TO:	Emily Wentworth, Town of Hingham	DATE:	March 30, 2016
FROM:	Joe SanClemente, P.E., AICP	HSH PROJECT NO.:	2015151.01
SUBJECT:	Avalon Hingham Shipyard II – 319 Lincoln Street Vanasse Traffic Peer Review – Response to Comments

Howard Stein Hudson (HSH) has prepared this memorandum in response to the comments received on the Avalon Hingham Shipyard II Project from the Town's peer review consultant, Vanasse & Associates, Inc. (VAI) in a memorandum dated March 10, 2016. Since that time the Proponent has reduced the scope of the Project to include just 190 residential units (60 fewer units) and associated adjustments to the site plan. HSH has prepared a technical memorandum documenting the change to the Proposed Project, the reduced traffic impacts, and the proposed mitigation.

Figure D.3. Fire Truck Turning Movements from Route 3A EB to Visitor Parking Lot

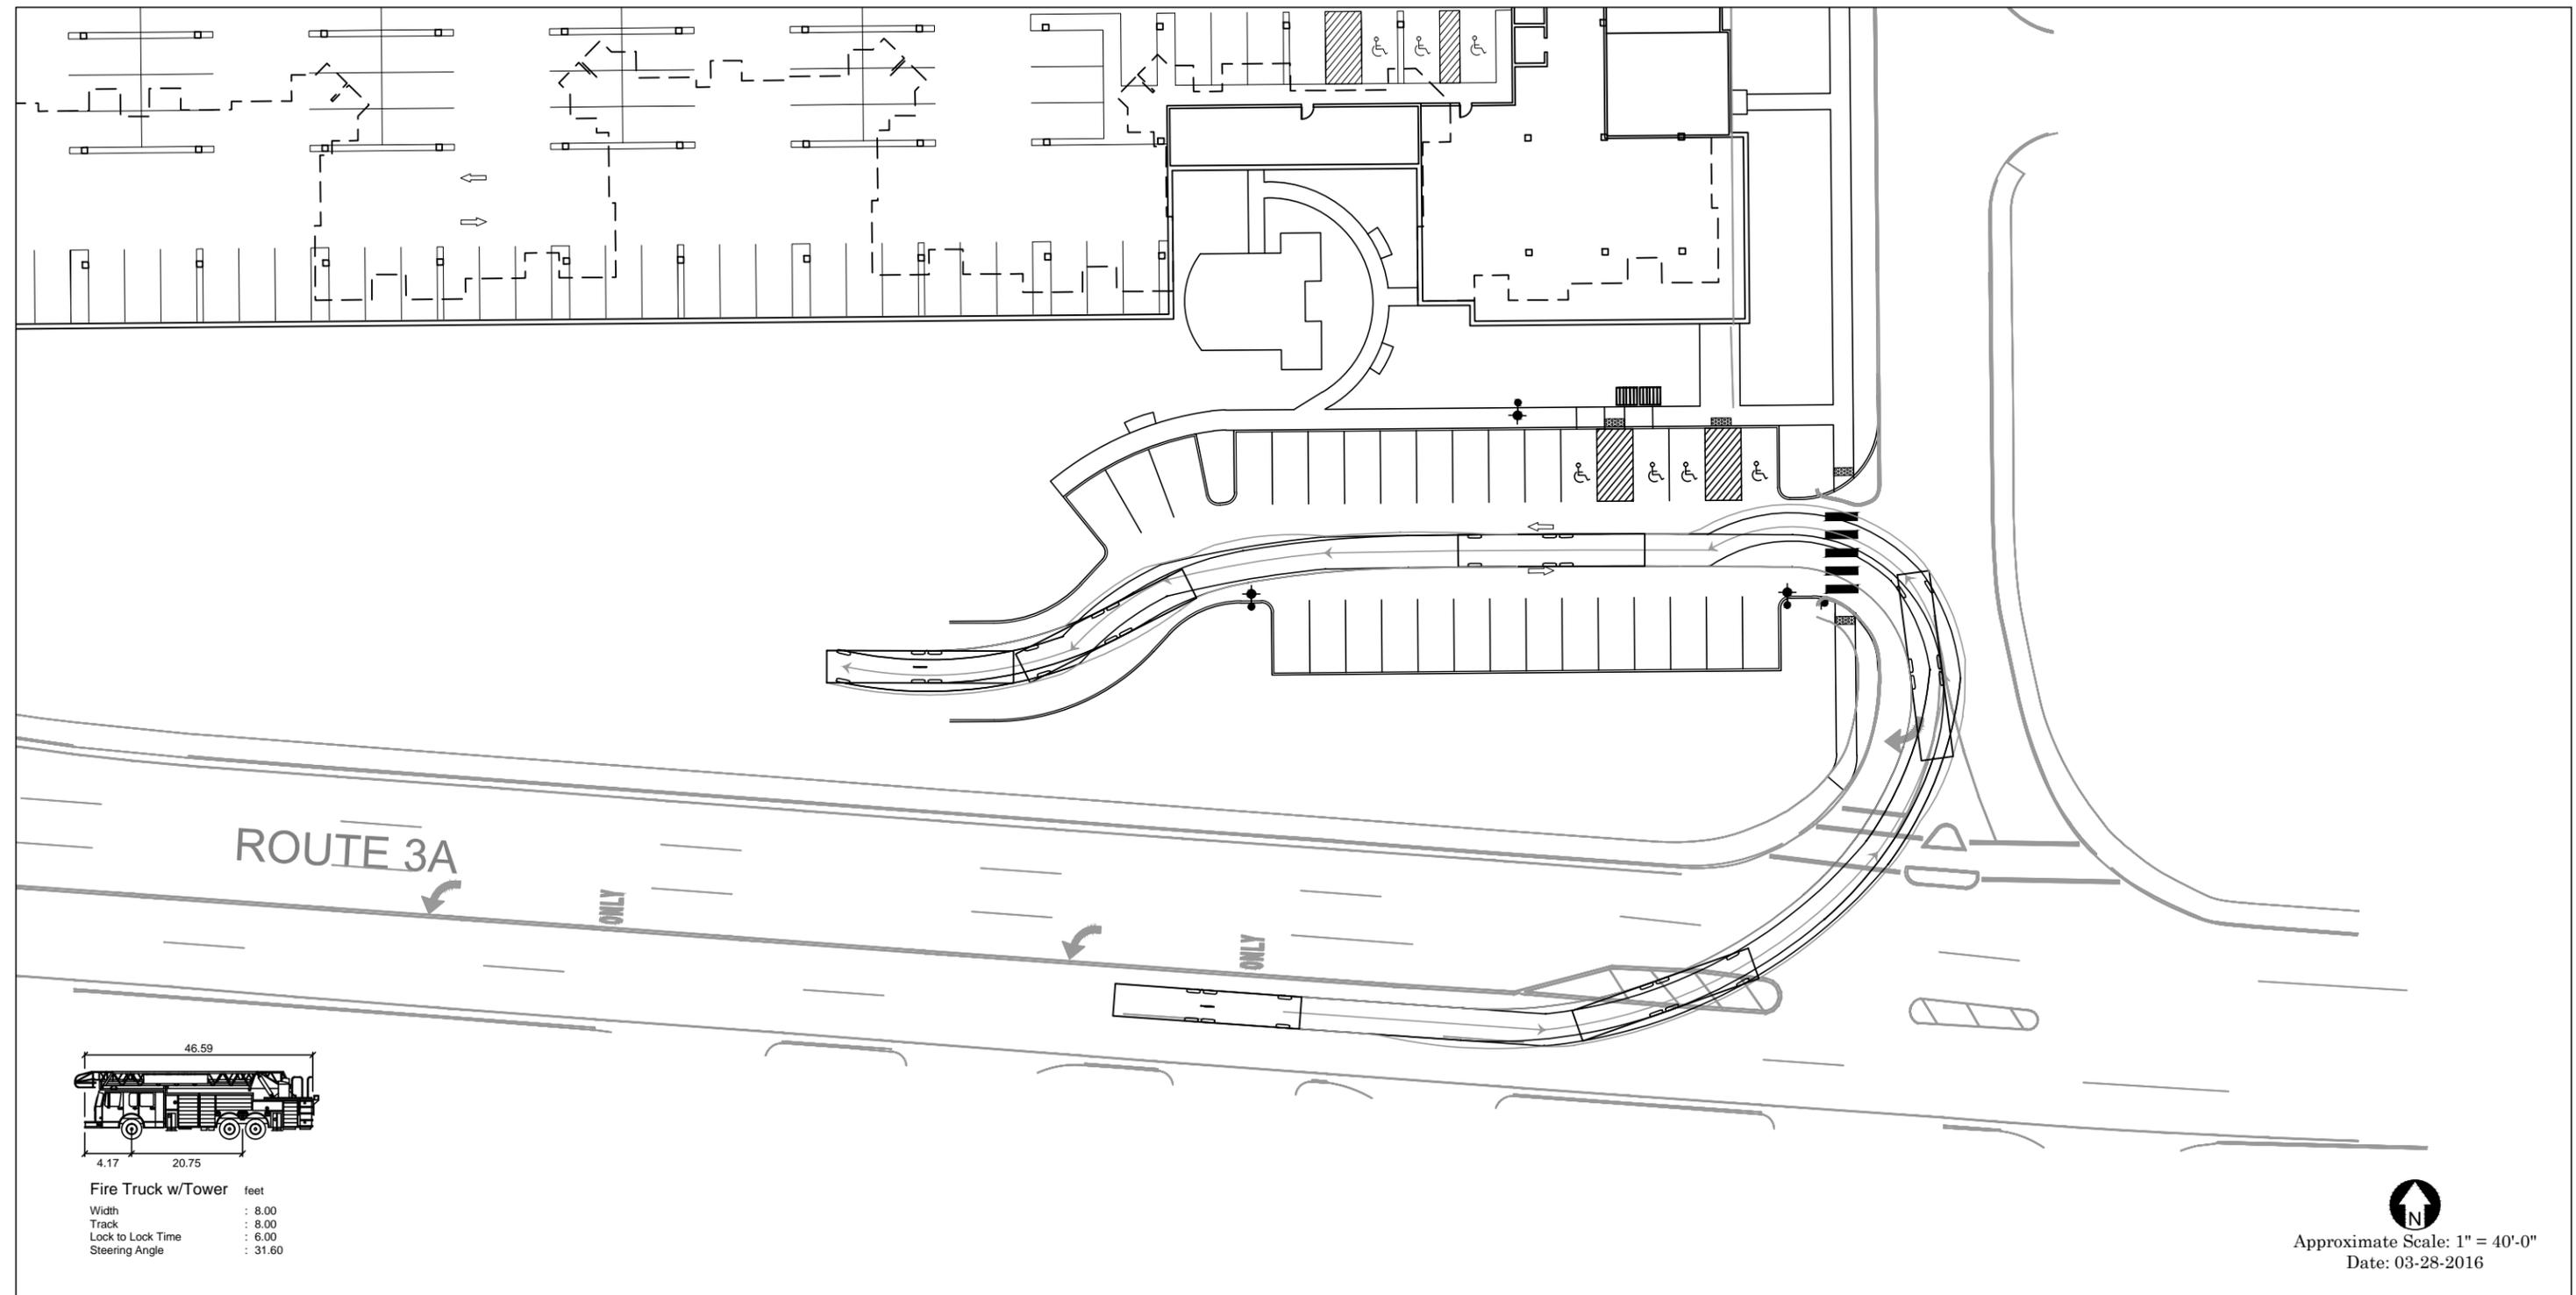
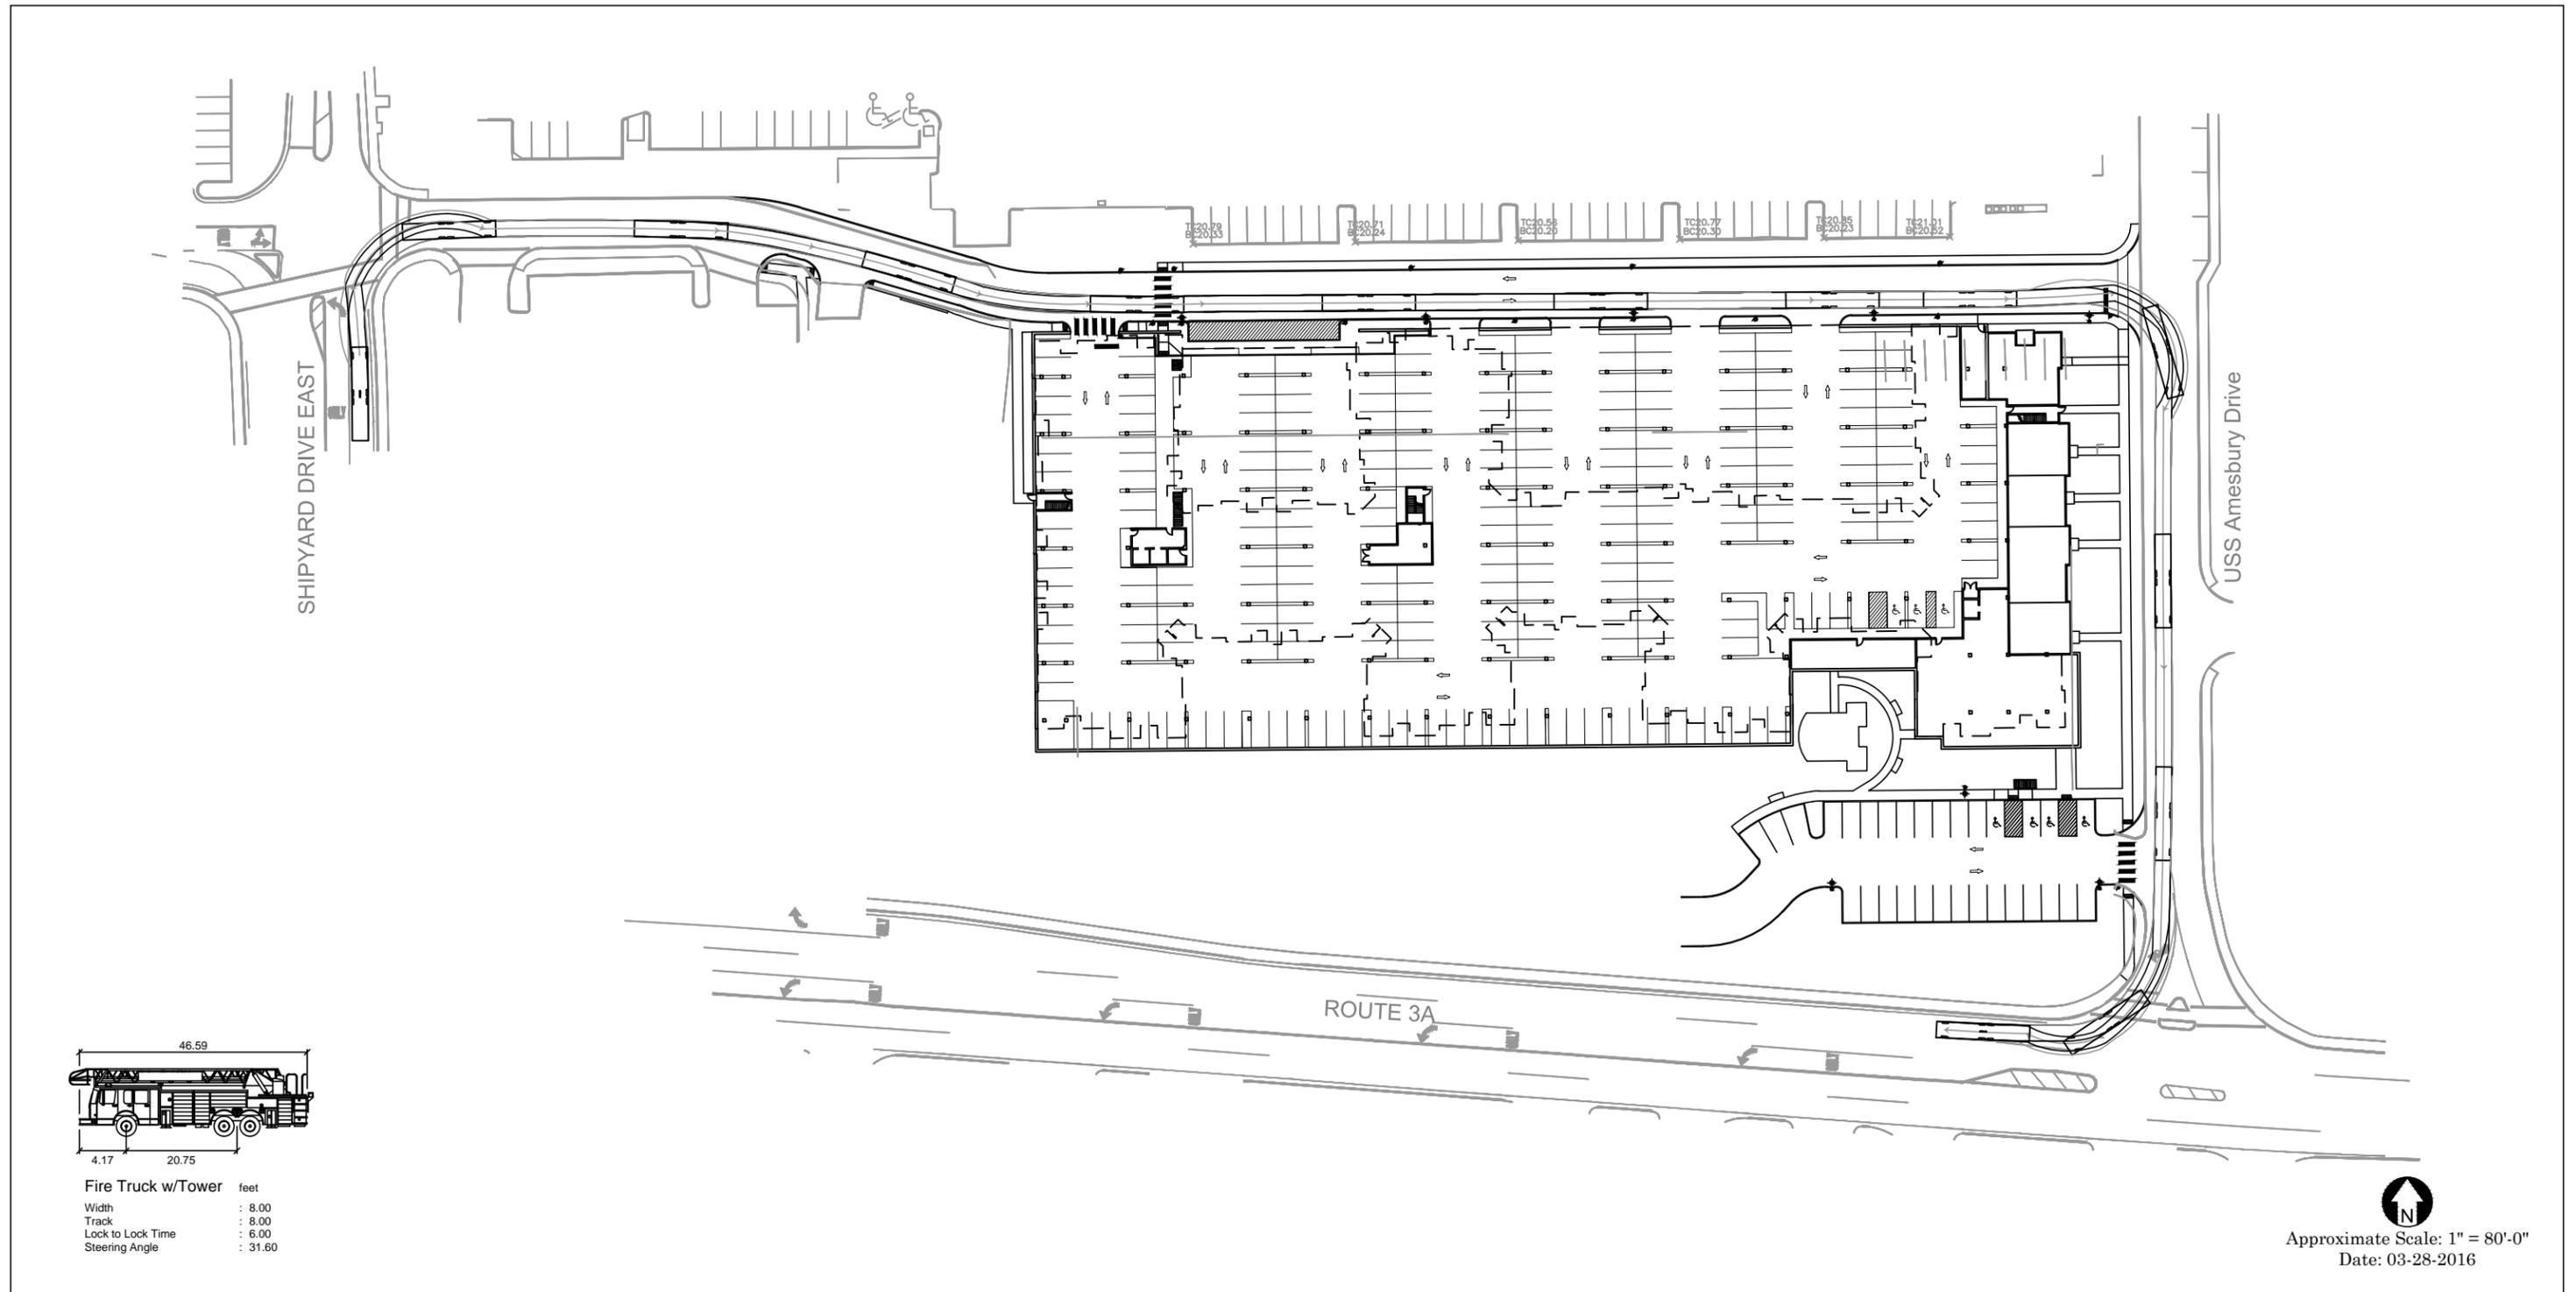
**Comment 1:** The Applicant's engineer provided a truck turning analysis for the Town of Hingham Fire Department design vehicle (tower truck) and an intermediate size tractor semi-trailer combination (WB-50). The turning analysis demonstrated that the subject vehicles can access and circulate within the Project site in an unimpeded manner; however, we note that the fire truck would need to back-up to exit the visitor parking area. The Applicant's engineer should also provide a turning analysis for an SU-30/40 (small delivery/moving vehicle and trash/recycling vehicle) that demonstrates that the subject vehicle can access and stage in the loading areas without blocking the garage access points. In addition, the analysis should also demonstrate the location and maneuvering required to serve the trash/recycling area.

Response 1: See attached truck turning analysis.
